3003 Runyon Canyon Project

Environmental Case: ENV-2016-4180-EIR
State Clearinghouse No.: 2018041016

March 2022

1. Introduction

Figure 1 – Google Earth Measurement Width of Roadway Along Edge of Project Parcel

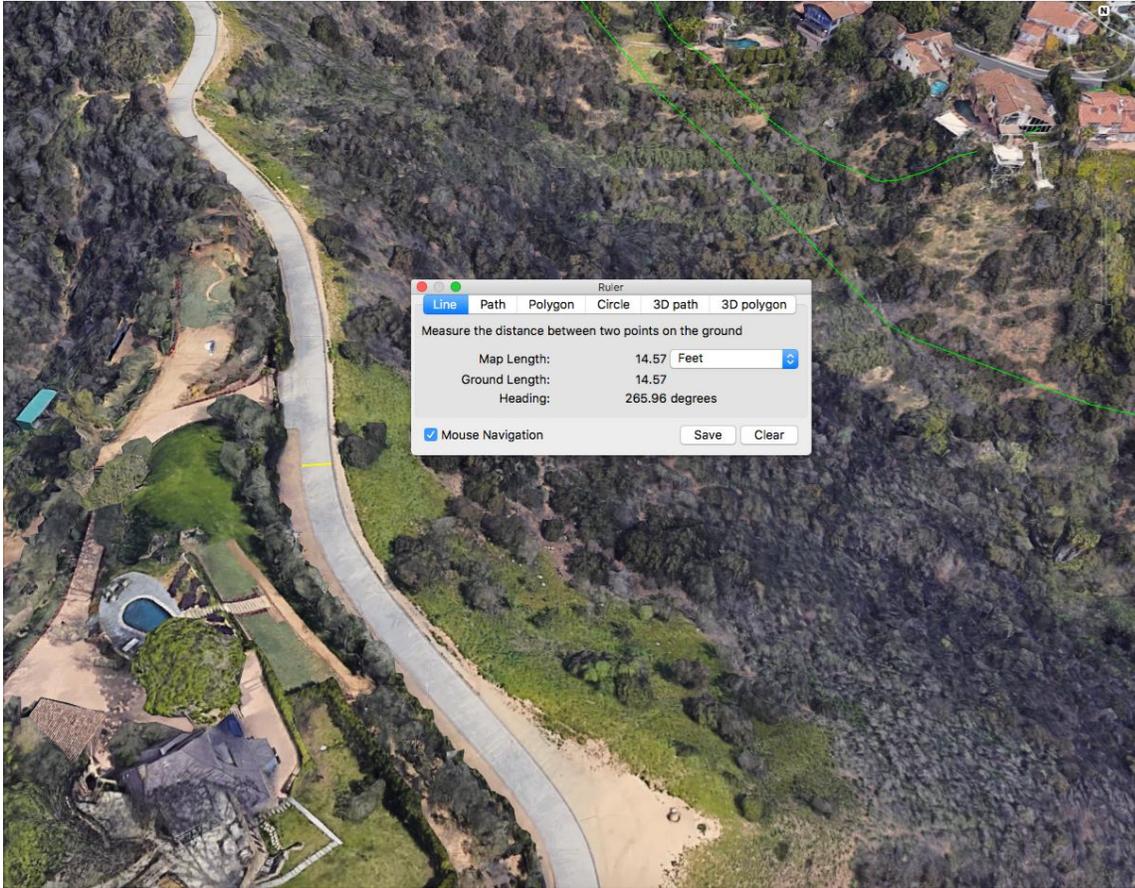
North Runyon Road is not a public street. The DEIR fails to identify the approvals required to allow new development on a parcel that does not abut a public street. The project description needs to describe any required improvements to North Runyon Road included as part of the proposed project; no such improvements are specified in the project description or included as mitigation measures. The project description or the existing setting needs to provide information on the existing roadway width of North Runyon Road and whether it meets applicable street access requirements in the Municipal Code, such as Section 12.21 C.10(i). Based on measurements taken using Google Earth, shown in **Figure 1**, it does not appear that North Runyon Road meets the requirements for a Standard Hillside Limited Street and would thus be considered a Substandard Hillside Limited Street. Failure to comply with Hillside Ordinance requirements regarding obligations for projects on a Substandard Hillside Limited Street should be identified as a significant land use impact in the DEIR.

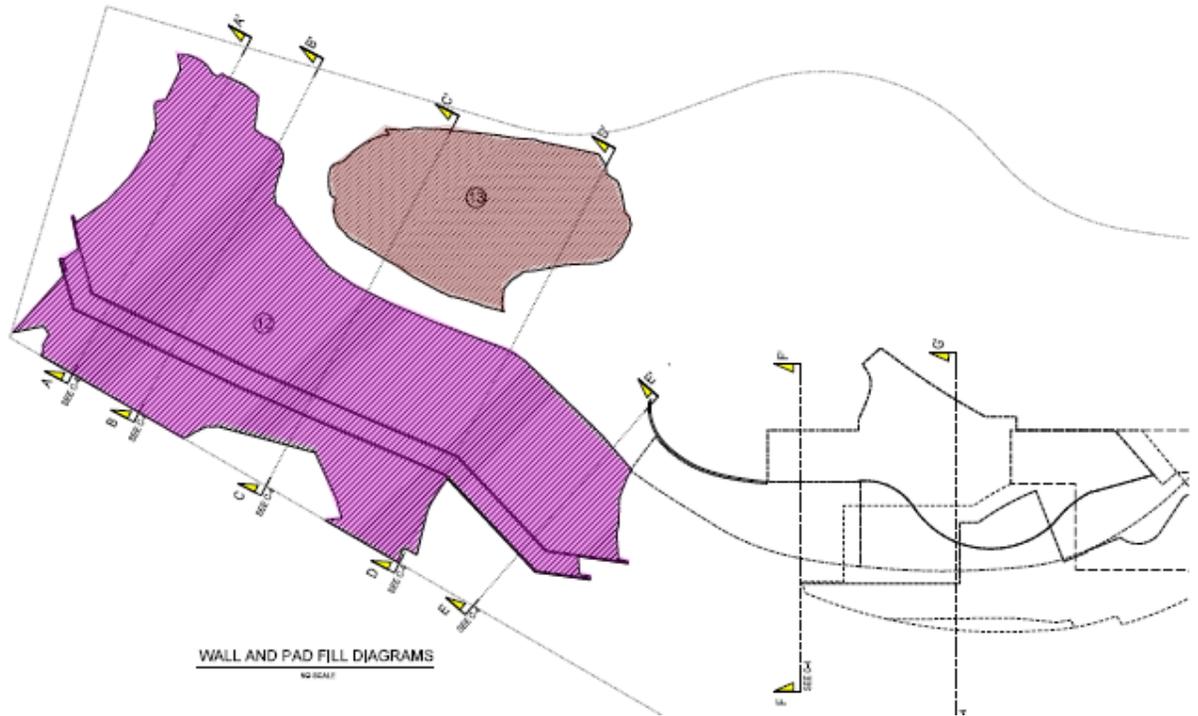
The analysis fails to address the potential aesthetic impacts of the fill sites, which would be clearly visible from Runyon Canyon Road. Information on the nature of postfill contours and landscaping should be provided. The analysis should address sight lines along the eastern project frontage. In the absence of such an analysis the potential for impacts remains.

As stated on page II-2, footnote 2, of the Draft EIR, the original ridgeline was significantly modified by the architect of the Headley/Handley House in the 1930s/1940s. As a result, the current ridgeline has been modified significantly from its original state. As shown in Draft EIR Figures II-3 and II-4 in Section II, Project Description, the portion of the Project Site that would accommodate the Project is currently a flat pad planted with grass. The roof of the proposed home has been designed such that it would match the existing, generally flat topography, and would also be planted with mixed meadow/meadow edge native grasses. Therefore, it was determined that the Project would replace the existing ridgeline in-kind.

Regarding the fill sites, the fill sites are located on the lower portions of the slope on the northern and western portions of the Project Site, by the existing pool and driveway and are shown in the figures below. In addition, proposed landscape plans have been included in Section 3, Revisions, Clarifications, and Corrections, of this Final EIR. As shown in new Figure II-19, the area of the proposed fill sites and retaining walls would be planted with mixed chaparral plants to mimic the variety and layout of the adjacent native chaparral. The plant colors would be consistent with the natural colors of the Santa Monica Mountains, and would also be consistent with the Santa Monica Mountain Plant Color Wheel. Finally, the commenter is also referred to new Figures IV.A-7 and IV.A-10 (in Section 3, Revisions, Clarifications, and Corrections), which provide sight line views

Figure 2 – Daylight Hours in Los Angeles During the Year Source:
<https://www.timeanddate.com/sun/usa/los-angeles>

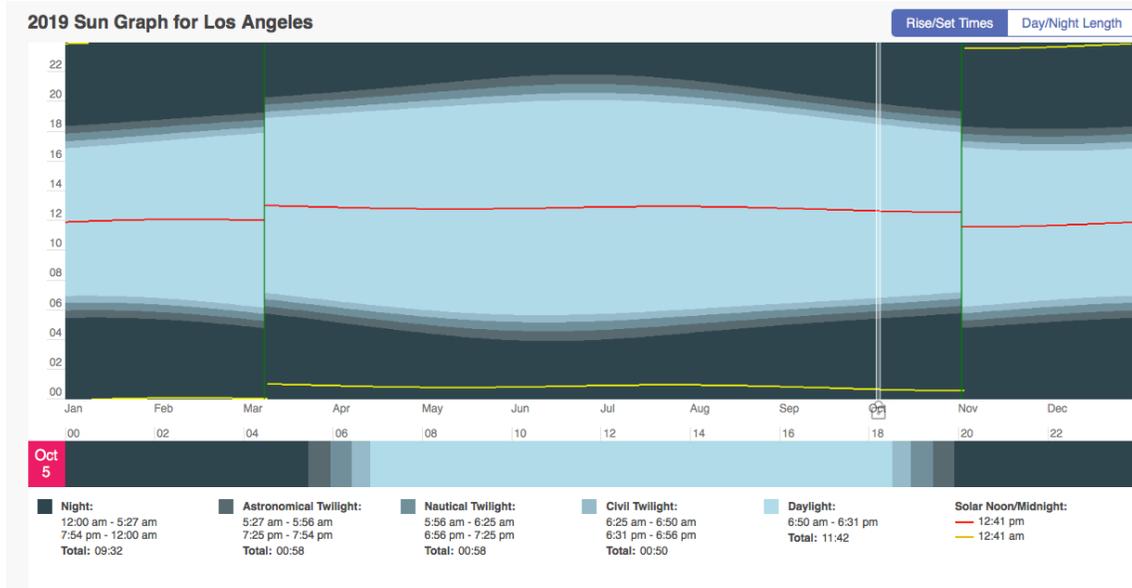
The analysis of construction lighting impacts assumes that no construction will occur during evening and nighttime hours (see DEIR page IV.A-13). However, the City of Los Angeles permits construction Monday through Friday from 7:00 a.m. to 9:00 p.m. and on Saturdays and National Holidays from 8:00 a.m. to 6:00 p.m. As shown in **Figure 2**, this would allow for construction after sunset. In the absence of a mitigation measure prohibiting lighted construction activity after dark, the potential for short-term lighting impacts remains. Lighting impacts are of particular concern given the project proximity to parkland containing wildlife resources that may be impacted by nighttime lighting.

Revised Figure II-1
 Proposed Site Plan

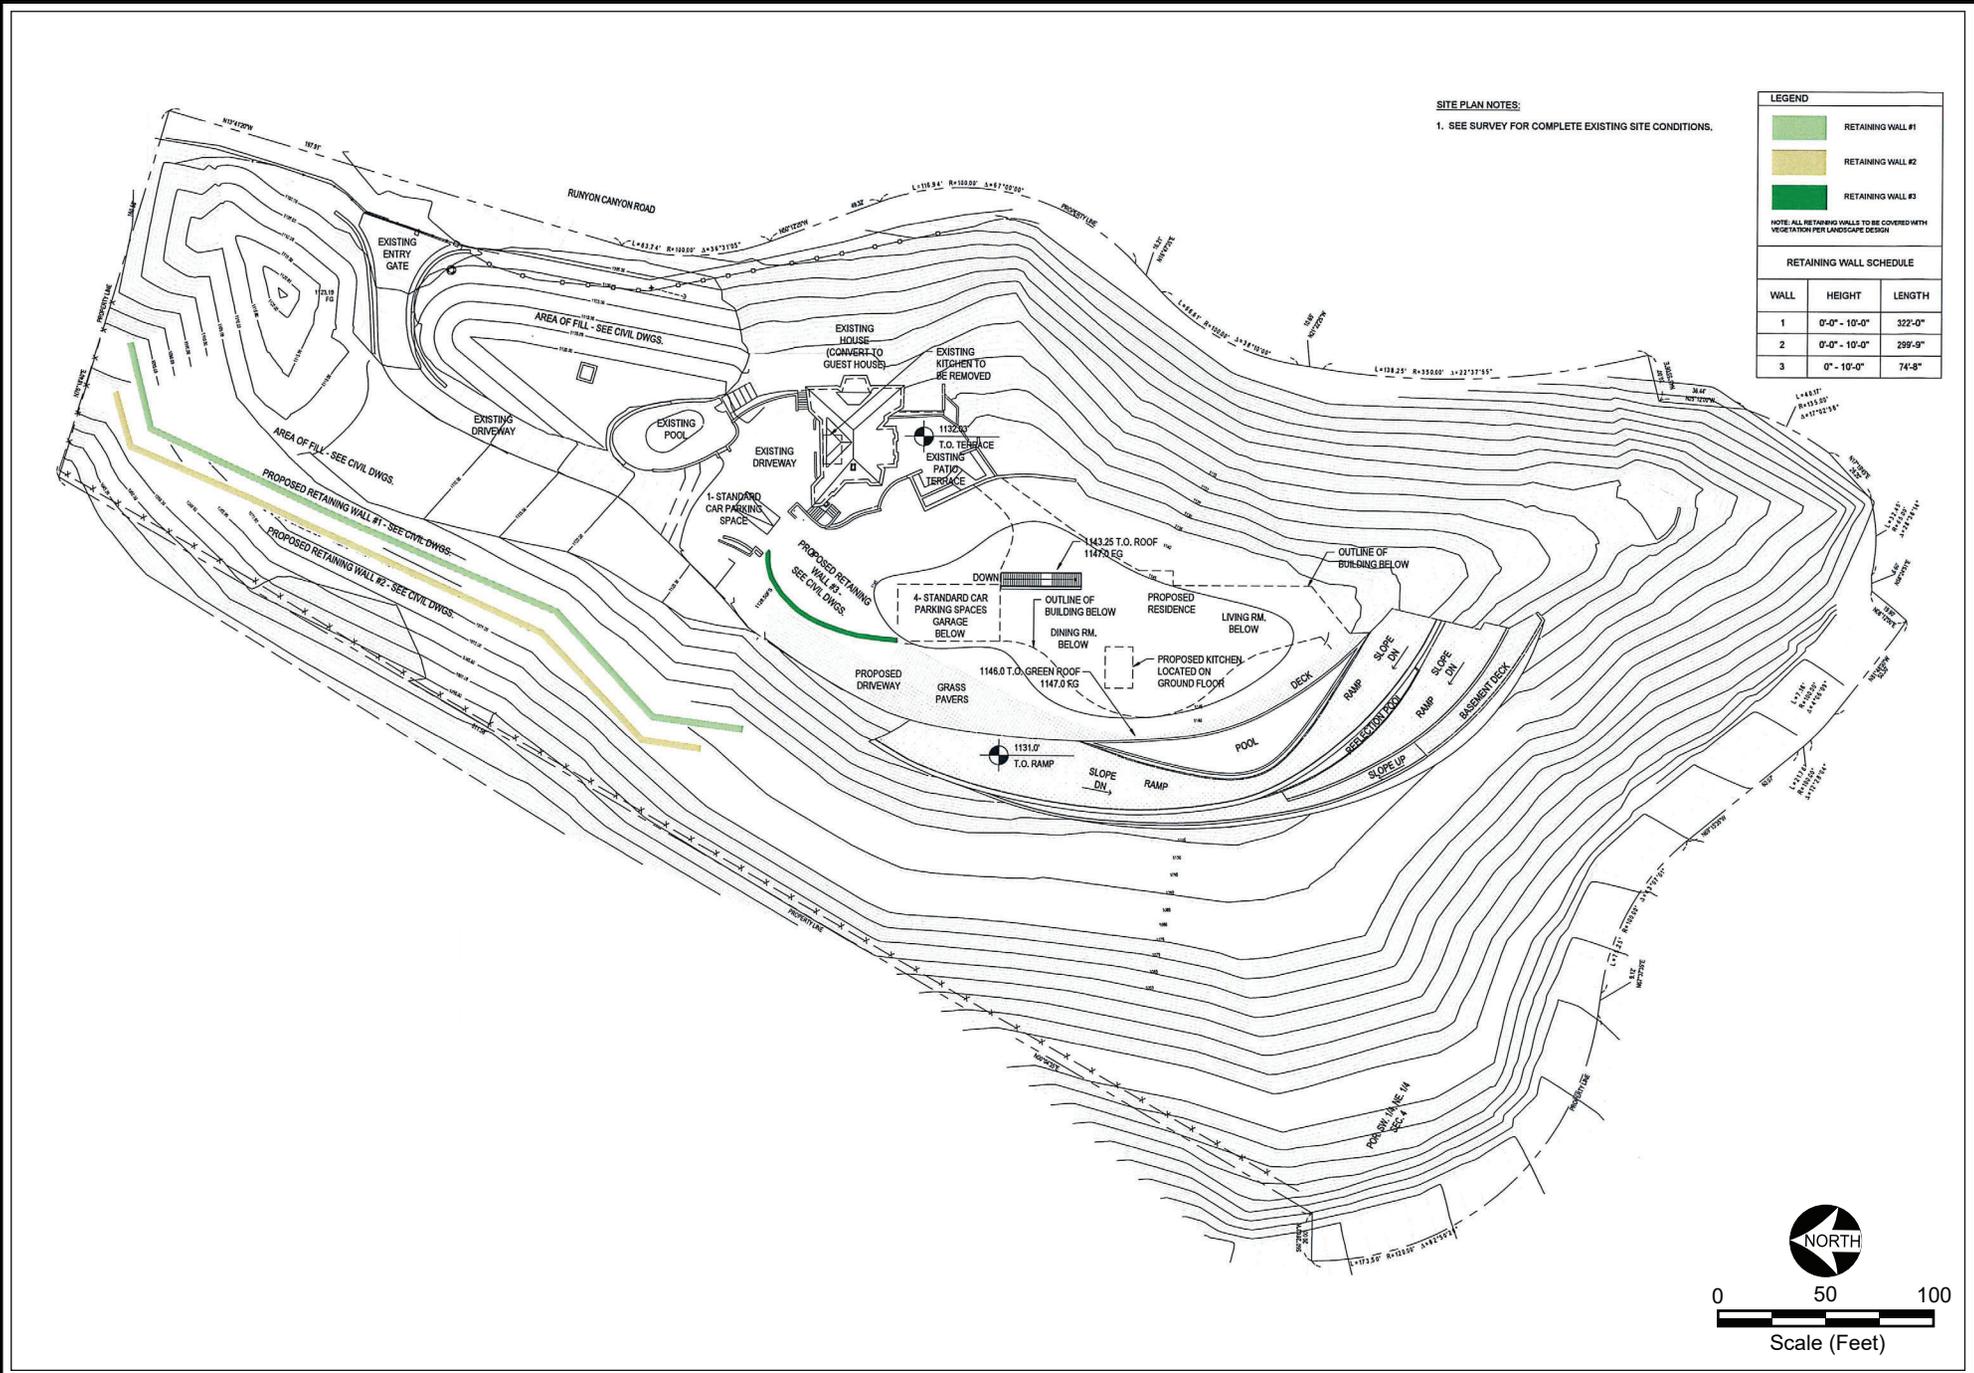
Figure II-1 needs to include a legend showing what the ziptone on the plan represents.

The ziptone on Figure II-1 represents the changes in elevation. This has also been clarified in Section 3, Revisions, Clarifications, and Corrections, of this Final EIR (Revised Figure II-1).

New Figure II-15
Location of Solar Panels

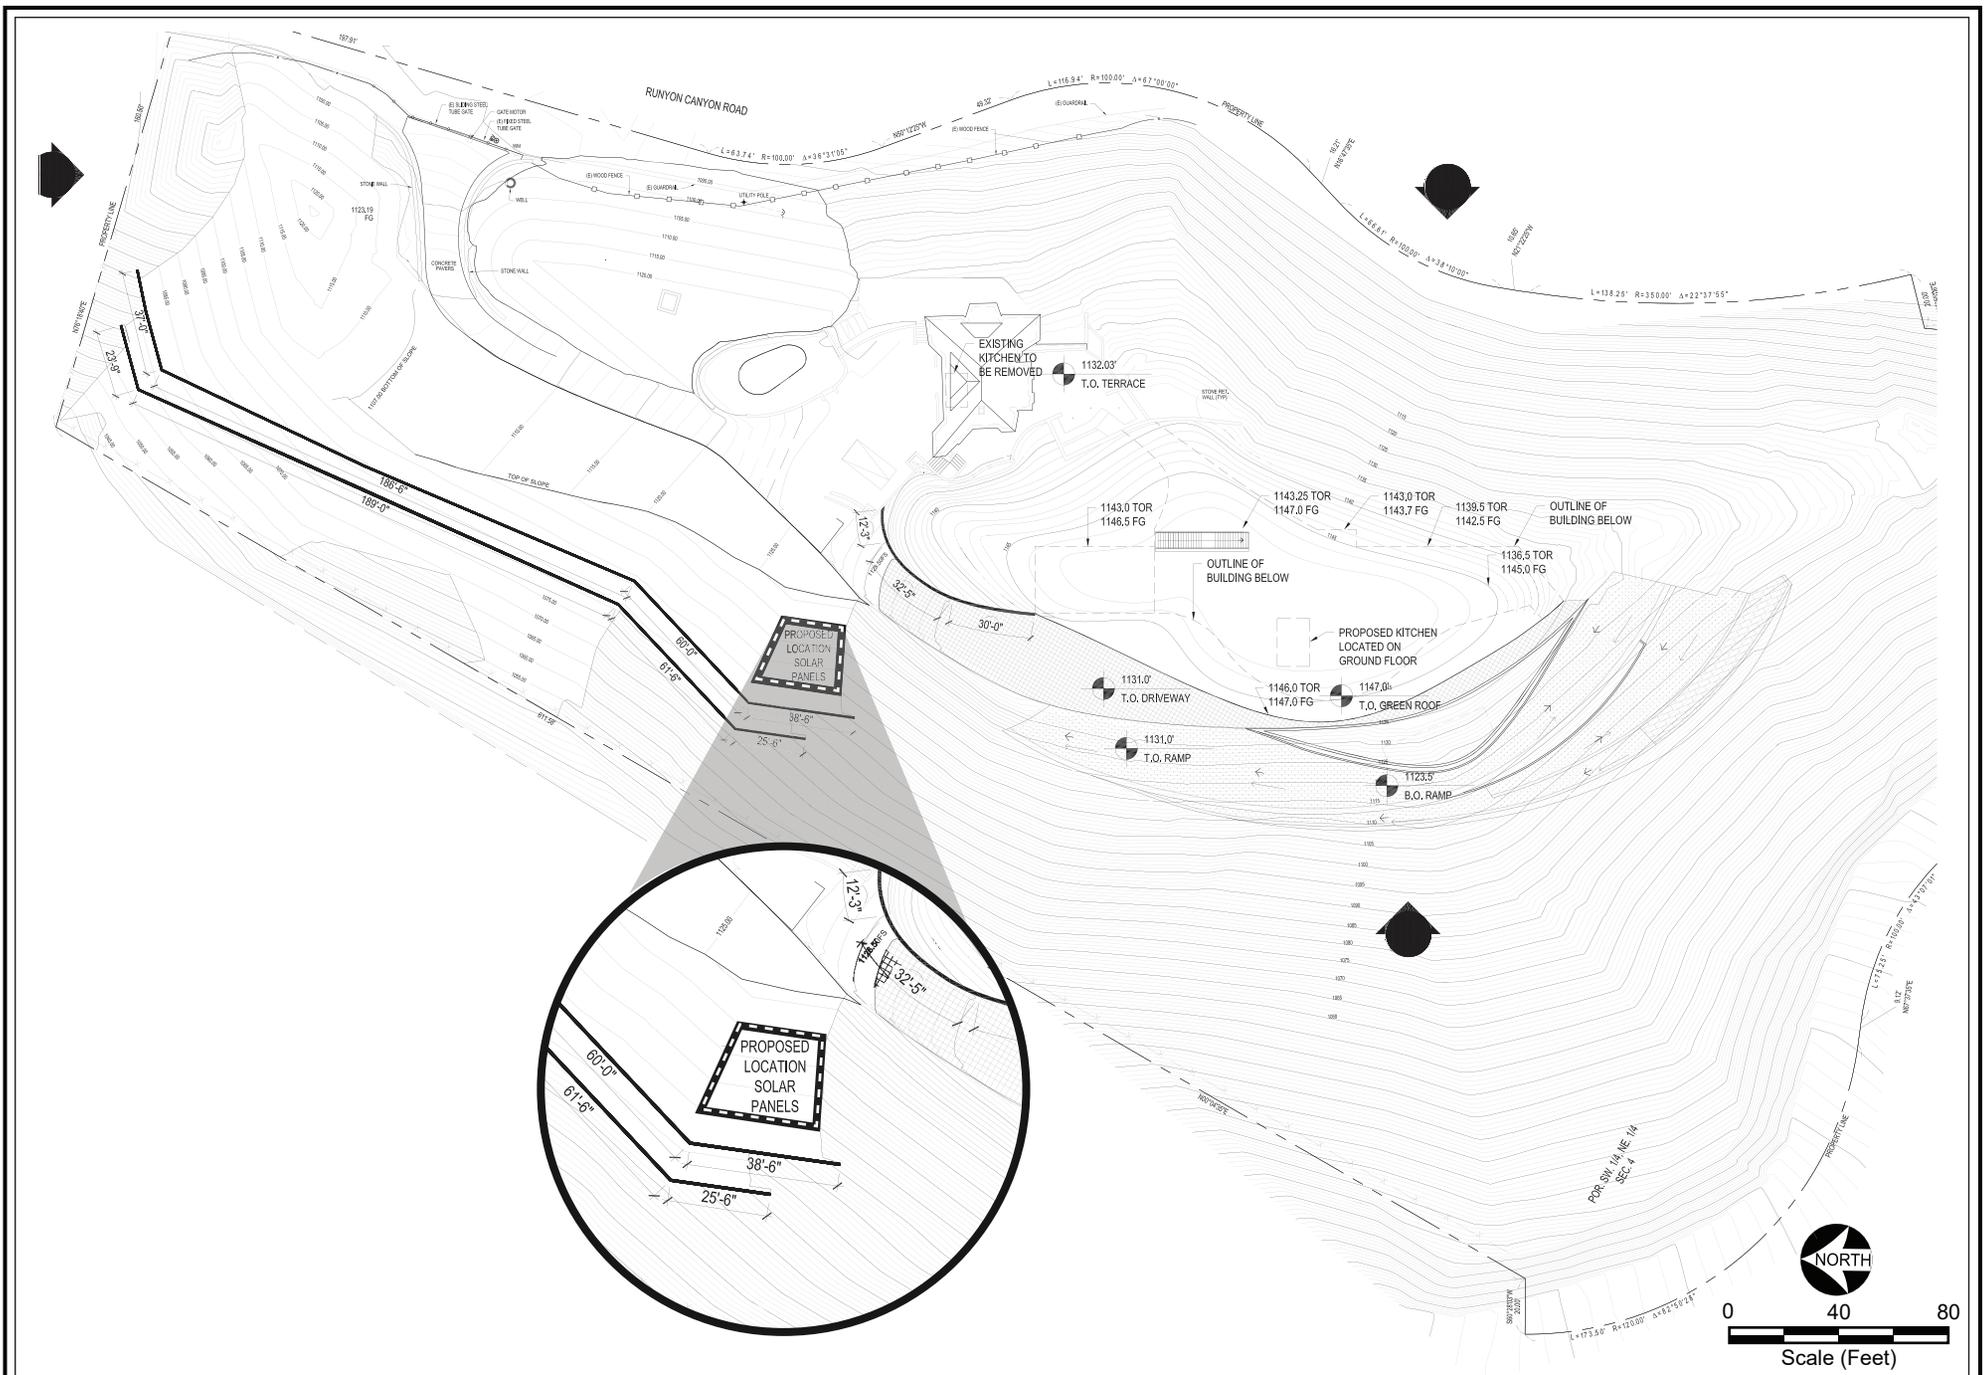
Figure II-5 indicates that solar panels may be placed on the roof of the residence. The DEIR narrative needs to provide information on the size of the paneled area and the aesthetic analysis needs to address whether panels would be visible from nearby hillside areas, such as those shown in Figure II-12 and whether they will result in a visible glare spot. The biological resource analysis needs to address the potential impacts of solar panels located in a key wildlife area and their potential impact on birds and other wildlife.

If solar panels are required, they would not be located on the roof of the proposed residence. Instead, as shown in new Figure II-15 (included in Section 3, Revisions, Clarifications, and Corrections, of this Final EIR), any required solar panels would be located on the fill site below the driveway, and therefore would have limited visibility from nearby hillside areas.
